From: [Cllr Tim Bamford](#)
To: [RichardA Gilbert](#)
Subject: Strata homes, Barnsley road, Denby Dale
Date: 24 April 2022 11:39:05
Attachments: [161 A201 53H Strata Highway Design Issues.pdf](#)

I am concerned about the highway issues at the access to this site from Barnsley Road.

EXTRACT OF PROPOSED ROAD DESIGN
TAKEN FROM ANDREW MOSELEY
ASSOCIATES DRAWING PUBLISHED BY
KIRKLEES 12/21 & USED FOR
ILLUSTRATIVE PURPOSES ONLY

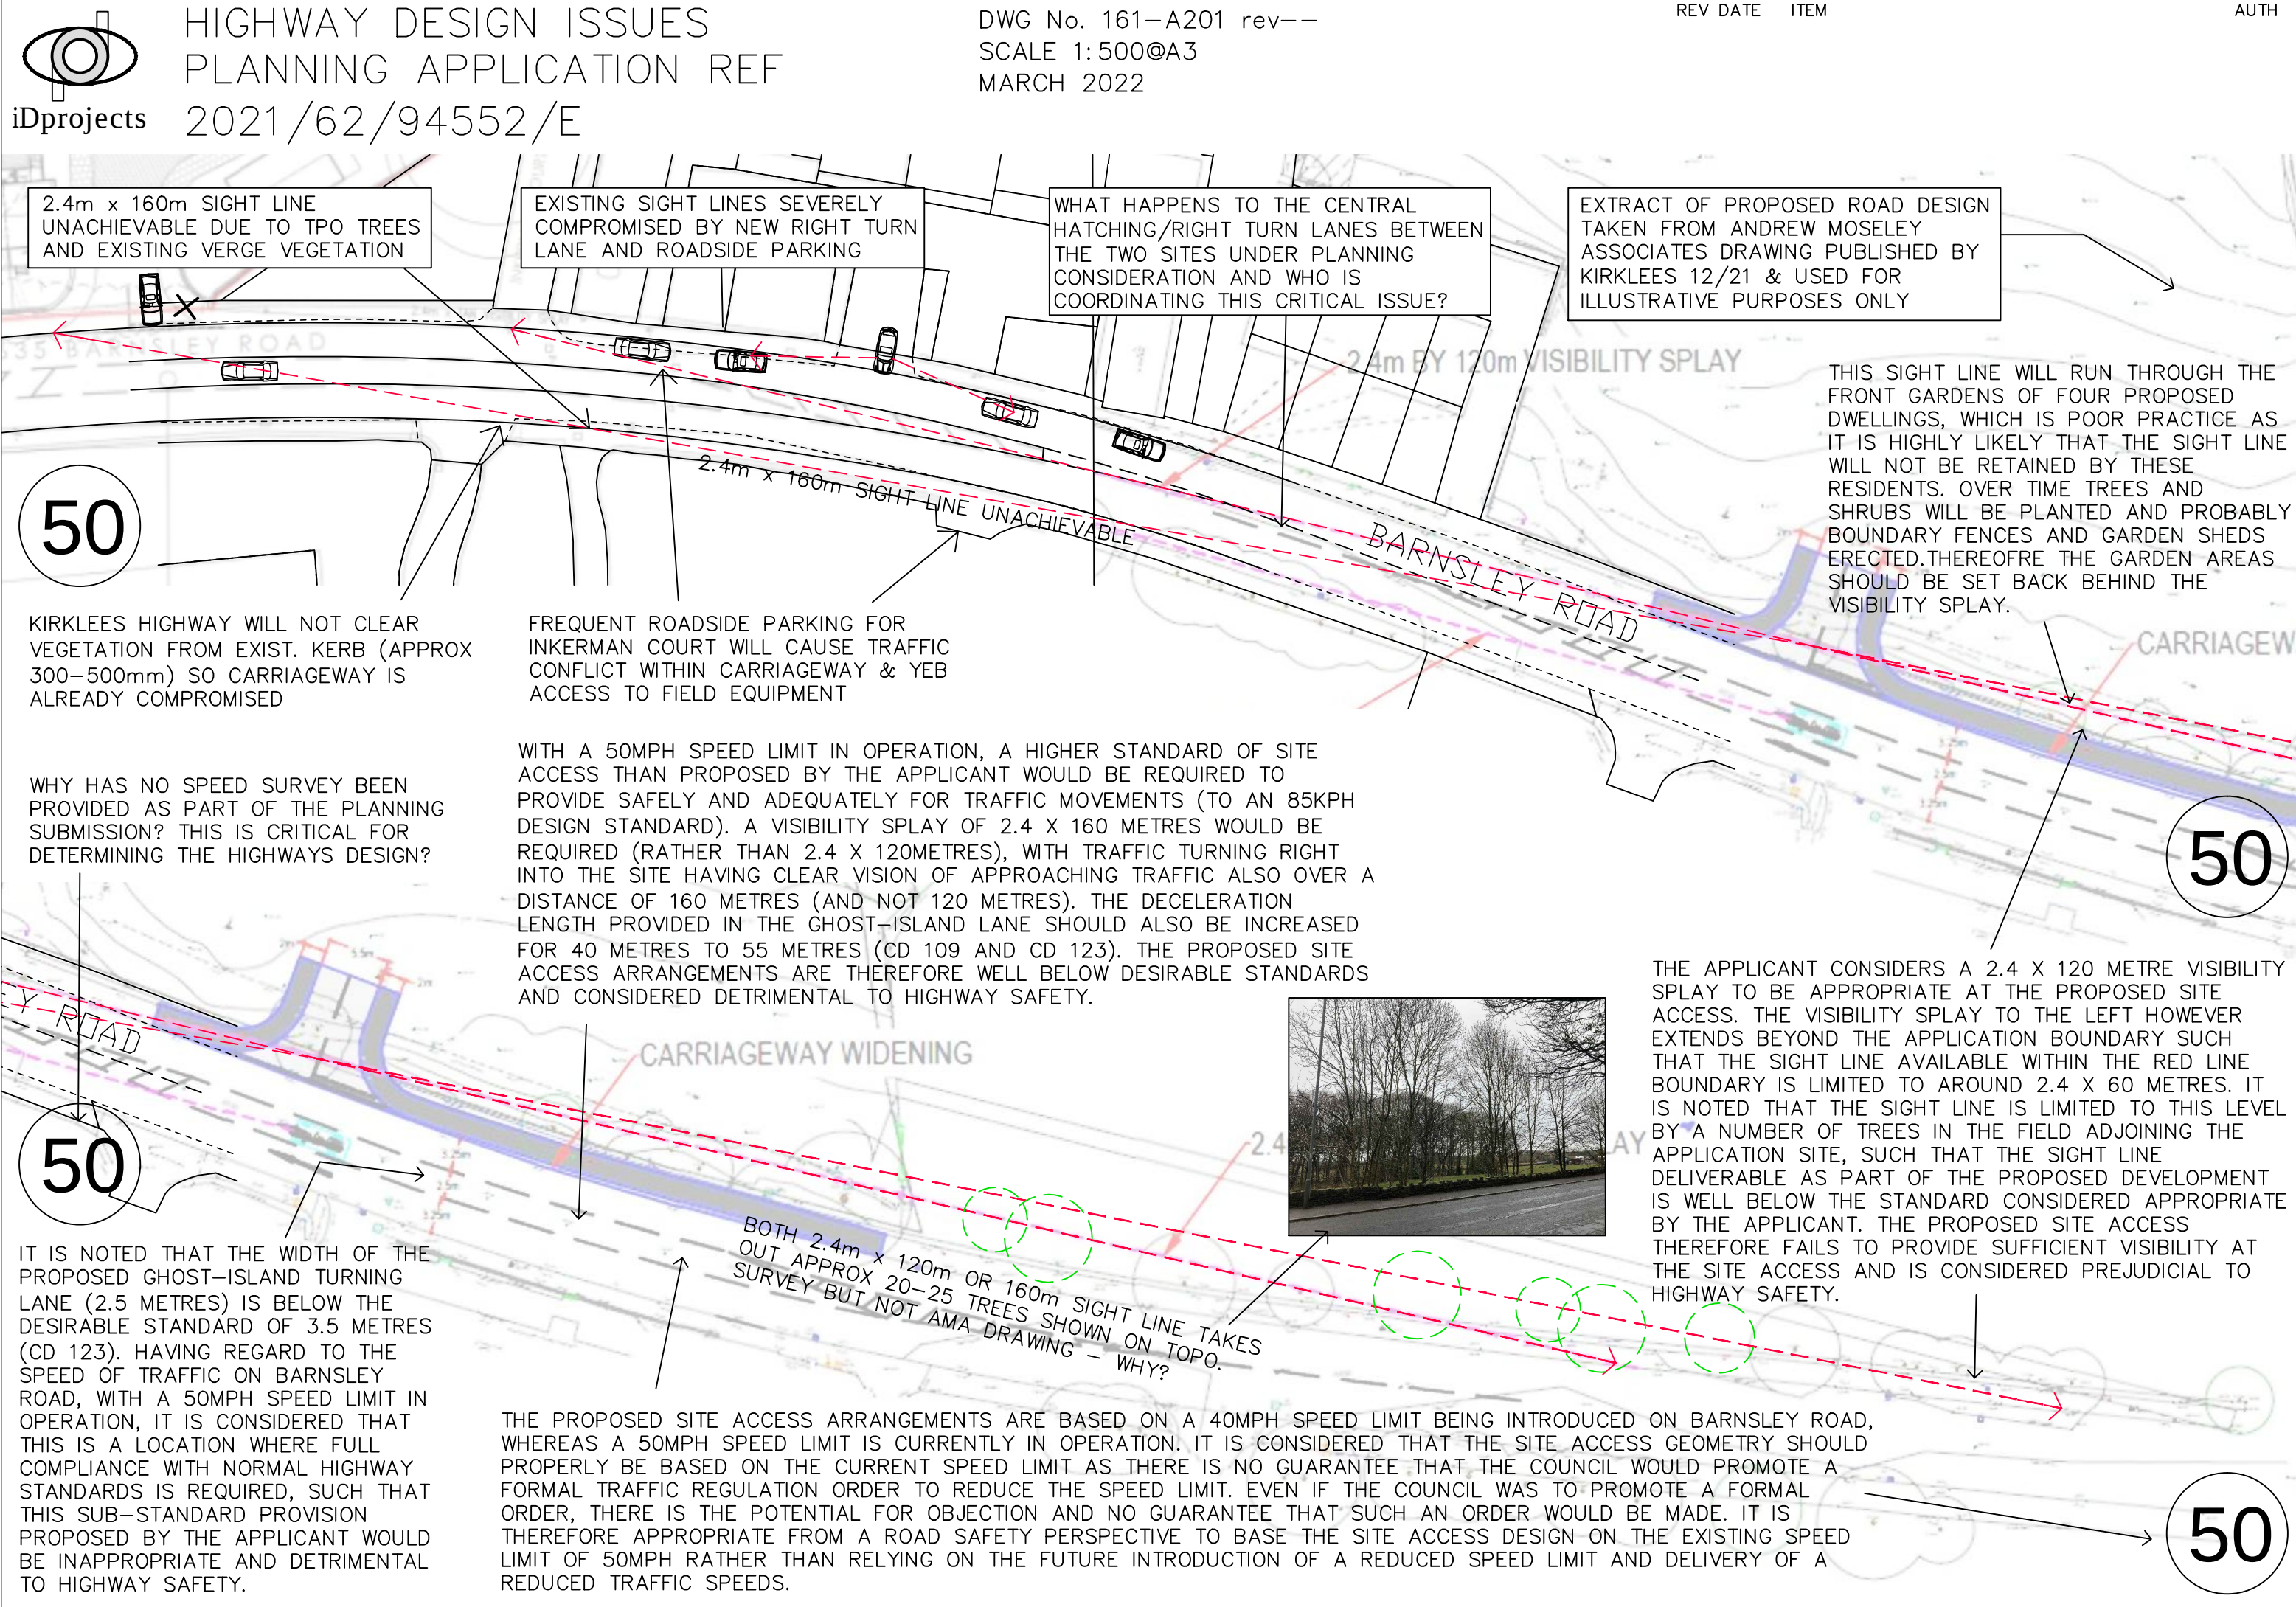
2.4m x 160m SIGHT LINE
UNACHIEVABLE DUE TO TPO TREES
AND EXISTING VERGE VEGETATION

EXISTING SIGHT LINES SEVERELY
COMPROMISED BY NEW RIGHT TURN
LANE AND ROADSIDE PARKING

WHAT HAPPENS TO THE CENTRAL
HATCHING/RIGHT TURN LANES BETWEEN
THE TWO SITES UNDER PLANNING
CONSIDERATION AND WHO IS
COORDINATING THIS CRITICAL ISSUE?

THIS SIGHT LINE WILL RUN THROUGH THE
FRONT GARDENS OF FOUR PROPOSED
DWELLINGS, WHICH IS POOR PRACTICE AS
IT IS HIGHLY LIKELY THAT THE SIGHT LINE
WILL NOT BE RETAINED BY THESE
RESIDENTS. OVER TIME TREES AND
SHRUBS WILL BE PLANTED AND PROBABLY
BOUNDARY FENCES AND GARDEN SHEDS
ERECTED.THEREOFRE THE GARDEN AREAS
SHOULD BE SET BACK BEHIND THE
VISIBILITY SPLAY.

KIRKLEES HIGHWAY WILL NOT CLEAR
VEGETATION FROM EXIST. KERB (APPROX
300-500mm) SO CARRIAGEWAY IS
ALREADY COMPROMISED

FREQUENT ROADSIDE PARKING FOR
INKERMAN COURT WILL CAUSE TRAFFIC
CONFLICT WITHIN CARRIAGEWAY & YEB
ACCESS TO FIELD EQUIPMENT

WHY HAS NO SPEED SURVEY BEEN
PROVIDED AS PART OF THE PLANNING
SUBMISSION? THIS IS CRITICAL FOR
DETERMINING THE HIGHWAYS DESIGN?

WITH A 50MPH SPEED LIMIT IN OPERATION, A HIGHER STANDARD OF SITE
ACCESS THAN PROPOSED BY THE APPLICANT WOULD BE REQUIRED TO
PROVIDE SAFELY AND ADEQUATELY FOR TRAFFIC MOVEMENTS (TO AN 85KPH
DESIGN STANDARD). A VISIBILITY SPLAY OF 2.4 X 160 METRES WOULD BE
REQUIRED (RATHER THAN 2.4 X 120METRES), WITH TRAFFIC TURNING RIGHT
INTO THE SITE HAVING CLEAR VISION OF APPROACHING TRAFFIC ALSO OVER A
DISTANCE OF 160 METRES (AND NOT 120 METRES). THE DECELERATION
LENGTH PROVIDED IN THE GHOST-ISLAND LANE SHOULD ALSO BE INCREASED
FOR 40 METRES TO 55 METRES (CD 109 AND CD 123). THE PROPOSED SITE
ACCESS ARRANGEMENTS ARE THEREFORE WELL BELOW DESIRABLE STANDARDS
AND CONSIDERED DETRIMENTAL TO HIGHWAY SAFETY.

THE APPLICANT CONSIDERS A 2.4 X 120 METRE VISIBILITY
SPLAY TO BE APPROPRIATE AT THE PROPOSED SITE
ACCESS. THE VISIBILITY SPLAY TO THE LEFT HOWEVER
EXTENDS BEYOND THE APPLICATION BOUNDARY SUCH
THAT THE SIGHT LINE AVAILABLE WITHIN THE RED LINE
BOUNDARY IS LIMITED TO AROUND 2.4 X 60 METRES. IT
IS NOTED THAT THE SIGHT LINE IS LIMITED TO THIS LEVEL
BY A NUMBER OF TREES IN THE FIELD ADJOINING THE
APPLICATION SITE, SUCH THAT THE SIGHT LINE
DELIVERABLE AS PART OF THE PROPOSED DEVELOPMENT
IS WELL BELOW THE STANDARD CONSIDERED APPROPRIATE
BY THE APPLICANT. THE PROPOSED SITE ACCESS
THEREFORE FAILS TO PROVIDE SUFFICIENT VISIBILITY AT
THE SITE ACCESS AND IS CONSIDERED PREJUDICIAL TO
HIGHWAY SAFETY.

IT IS NOTED THAT THE WIDTH OF THE
PROPOSED GHOST-ISLAND TURNING
LANE (2.5 METRES) IS BELOW THE
DESIRABLE STANDARD OF 3.5 METRES
(CD 123). HAVING REGARD TO THE
SPEED OF TRAFFIC ON BARNSELEY
ROAD, WITH A 50MPH SPEED LIMIT IN
OPERATION, IT IS CONSIDERED THAT
THIS IS A LOCATION WHERE FULL
COMPLIANCE WITH NORMAL HIGHWAY
STANDARDS IS REQUIRED, SUCH THAT
THIS SUB-STANDARD PROVISION
PROPOSED BY THE APPLICANT WOULD
BE INAPPROPRIATE AND DETRIMENTAL
TO HIGHWAY SAFETY.

THE PROPOSED SITE ACCESS ARRANGEMENTS ARE BASED ON A 40MPH SPEED LIMIT BEING INTRODUCED ON BARNSELEY ROAD,
WHEREAS A 50MPH SPEED LIMIT IS CURRENTLY IN OPERATION. IT IS CONSIDERED THAT THE SITE ACCESS GEOMETRY SHOULD
PROPERLY BE BASED ON THE CURRENT SPEED LIMIT AS THERE IS NO GUARANTEE THAT THE COUNCIL WOULD PROMOTE A
FORMAL TRAFFIC REGULATION ORDER TO REDUCE THE SPEED LIMIT. EVEN IF THE COUNCIL WAS TO PROMOTE A FORMAL
ORDER, THERE IS THE POTENTIAL FOR OBJECTION AND NO GUARANTEE THAT SUCH AN ORDER WOULD BE MADE. IT IS
THEREFORE APPROPRIATE FROM A ROAD SAFETY PERSPECTIVE TO BASE THE SITE ACCESS DESIGN ON THE EXISTING SPEED
LIMIT OF 50MPH RATHER THAN RELYING ON THE FUTURE INTRODUCTION OF A REDUCED SPEED LIMIT AND DELIVERY OF A
REDUCED TRAFFIC SPEEDS.

BOTH 2.4m x 120m OR 160m SIGHT LINE TAKES
OUT APPROX 20-25 TREES SHOWN ON TOPO.
SURVEY BUT NOT AMA DRAWING - WHY?
